HOLMES SUBDIVISION

Engineering Comments: FINAL PLAT COMMENTS (should be addressed prior to submitting the FINAL PLAT for review and/or signature by the City Engineer):

APPLICATION NUMBER 3 DATE April 21, 2022

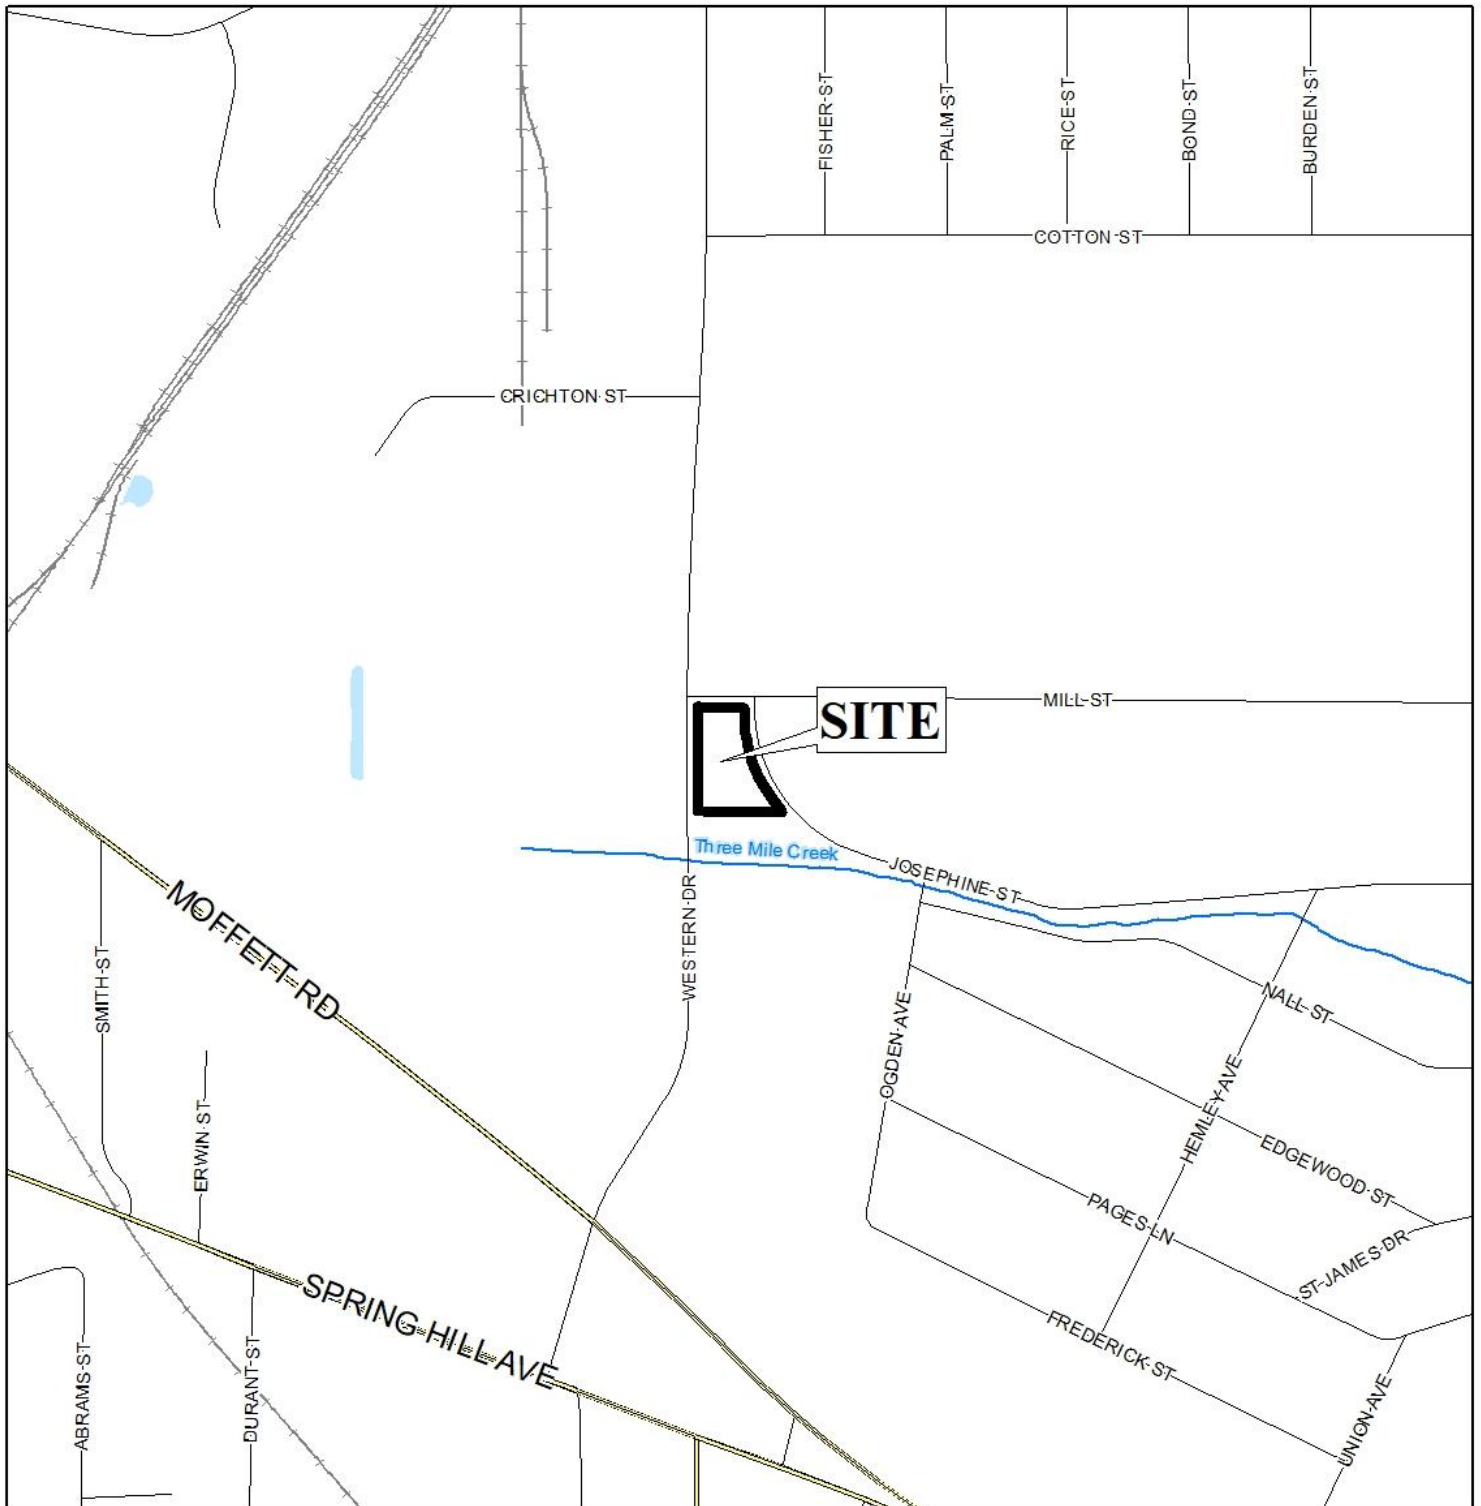
- B. Provide and label the monument set or found at each subdivision corner.
- C. Add a graphic scale.
- D. List the amount of ROW being dedicated (square feet and acres) for each of the corner dedications.

- E. Revise "...TO BE DEDICATED..." to "...HEREBY DEDICATED..." for each radius dedication.
- F. Add a signature block for the Planning Commission, Traffic Engineer, and City Engineer.

- G. Provide the Surveyor's Certificate.
- H. Add a note to the SUBDIVISION PLAT stating that as shown on the 1984 aerial photo (FLIGHT 25 - #69) LOTS 1, 2, & 3 will receive historical credit of existing (1984) impervious area towards stormwater detention requirement per Mobile City Code, Chapter 17, Storm Water Management and Flood Control) as follows: LOT 1 – NONE, LOT 2 – 5,800 sf, and LOT 3 – 5,000 sf.

The subject site has frontage on Western Drive, Mill Street and Josephine Street, all minor streets with 50-foot rights-of-way and curb and gutter; therefore, no frontage dedication would be required. The right-of-way widths of all streets should be retained on the Final Plat, if approved. The preliminary plat indicates a ten-foot radius curve dedication at the intersection of Western Drive and Mill Street, and at the intersection of Mill Street and Josephine Street. Section V.D.6. of the Subdivision Regulations allows a ten-foot radius curve minimum at intersections. Therefore, this should be retained on the Final Plat, or a greater radius dedication should be provided, if required by City Engineering.

The plat indicates a 25-foot minimum building setback line along Western Drive and Josephine Street, considered front streets, and this should be retained on the Final Plat. A 20-foot minimum building setback line is indicated along Mill Street. As Mill Street could be considered the side street, and as the Zoning Ordinance allows a 20-foot minimum building setback line along side streets, the reduced setback would be justified along Mill Street, and should be retained on the Final Plat.

In compliance with the Subdivision Regulations, the proposed lots exceed the minimum size requirements. The lots are labeled with their sizes in both square feet and acres on the preliminary plat, and these labels should be retained on the Final Plat, adjusted for any required dedication, or a table should be furnished on the Final Plat providing the same information.

The applicant proposes to retain the existing curb cuts on new Lots 2 and 3, and one curb cut onto Josephine Street for Lot 1. As this is a light industrial area as per the current zoning classification and land use, and as per the Future Land Use Map, curb cut allowances should be determined by Traffic Engineering. As per the Traffic Engineering comments, the driveway number, size, location, and design are to be approved by Traffic Engineering and conform to AASHTO standards. Any required on-site parking, including ADA handicap spaces, shall meet the minimum standards as defined in Section 64-6 of the City's Zoning Ordinance. A note should be required on the Final Plat stating these comments.

It should be noted that the preliminary plat indicates paved access between all three proposed lots. If shared access and/or parking is proposed between any of the lots, an Administrative Planned Unit Development will be required to allow such.

- 1) retention of the right-of-way widths of all streets on the Final Plat;

- 2) retention of the ten-foot radius curve dedication at the intersection of Western Drive and Mill Street, and at the intersection of Mill Street and Josephine Street on the Final Plat, or a greater radius dedication should be provided, if required by City Engineering;

- 3) retention of the 25-foot minimum building setback line along Western Drive and Josephine Street on the Final Plat;
- 4) retention of the 20-foot minimum building setback line along Mill Street on the Final Plat;

- 5) retention of the lot size labels on the Final Plat, adjusted for any required dedication, or the furnishing of a table on the Final Plat providing the same information;

- 6) approval of an Administrative Planned Unit Development if shared access and/or parking is proposed between any of the lots;
- 7) compliance with the Engineering comments: FINAL PLAT COMMENTS (should be addressed prior to submitting the FINAL PLAT for review and/or signature by the City Engineer): A. Provide all of the required information on the SUBDIVISION PLAT (i.e. signature blocks, signatures, certification statements, written legal description, required notes, legend, scale, bearings and distances) that is required by the current Alabama State Board of Licensure for Professional Engineers and Land Surveyors. B. Provide and label the monument set or found at each subdivision corner. C. Add a graphic scale. D. List the amount of ROW being dedicated (square feet and acres) for each of the corner dedications. E. Revise "...TO BE DEDICATED..." to "...HEREBY DEDICATED..." for each radius dedication. F. Add a signature block for the Planning Commission, Traffic Engineer, and City Engineer. G. Provide the Surveyor's Certificate. H. Add a note to the SUBDIVISION PLAT stating that as shown on the 1984 aerial photo (FLIGHT 25 - #69) LOTS 1, 2, & 3 will receive historical credit of existing (1984) impervious area towards stormwater detention requirement per Mobile City Code, Chapter 17, Storm Water Management and Flood Control) as follows: LOT 1 – NONE, LOT 2 – 5,800 sf, and LOT 3 – 5,000 sf. I. Add a note that a Land Disturbance permit will be required for any land disturbing activity in accordance with Mobile City Code, Chapter 17, Storm Water Management and Flood Control); the City of Mobile, Alabama Flood Plain Management Plan (1984); and, the Rules For Erosion and Sedimentation Control and Storm Water Runoff Control. J. Add a note that the approval of all applicable federal, state, and local agencies (including all storm water runoff, wetland and floodplain requirements) will be required prior to the issuance of a Land Disturbance permit. K. Add a note that sidewalk is required to be constructed, and/or repaired, along the frontage of each lot, or parcel, at time of new development or construction, unless a sidewalk waiver is approved. L. Add a note that all existing and proposed detention facilities, common areas, and wetlands shall be the responsibility of the Property Owner(s), and not the responsibility of the City of Mobile. M. Add a note that all easements shall remain in effect until vacated through the proper Vacation process. N. Email a pdf copy of the FINAL SUBDIVISION PLAT and LETTER OF DECISION to the Permitting Engineering Dept. for review at land.disturbance@cityofmobile.org prior to obtaining any signatures. No signatures are required on the drawing. O. After addressing all of the FINAL SUBDIVISION PLAT review comments provide the ORIGINAL (with all signatures except for the Planning Commission, Traffic Engineering, and City Engineer), one (1) copy, and a transmittal letter to the Engineering Permitting Department. They can be dropped off at 205 Government St. or mailed to PO Box 1827, Mobile, AL, 36633.);
